RE: Objection to Planning Application HGY/2024/0921 - Fire Statement Form
Inaccuracies and Inconsistencies

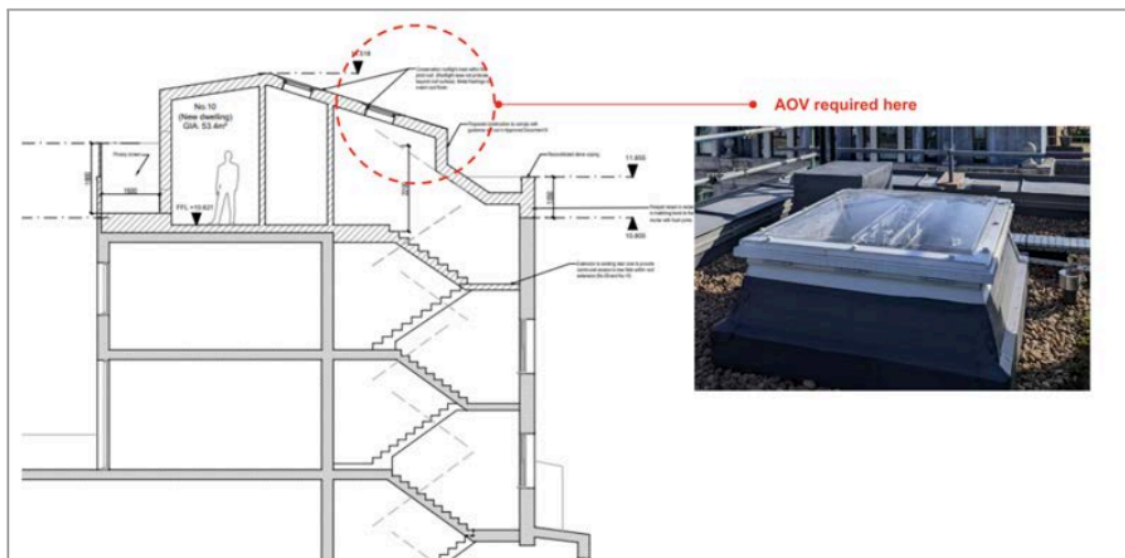
- **Structural Load & Buildability:** A 4,000-litre tank and equipment exerts a static dead load of approximately **4.2 metric tonnes**. Placing this weight on a previously extended Victorian 4th-storey structure requires **significant** structural steel reinforcement. We previously submitted a structural report by Akera Engineers (dated 2 May 2024) which confirmed that the existing timber roof structure is incapable of supporting the new accommodation and that the applicant's proposed "shallow floor build-up" (approx

150-200mm) is insufficient even for standard residential loading. Adding a **4.2-tonne water tank in a small area** to this structure exacerbates this issue dramatically. To support this load, the floor build-up would need to increase significantly. The applicant's persistent claim of a shallow build-up viability has become not just optimistic, but arguably dangerous and fantastical unless demonstrated otherwise by competent structural engineers.
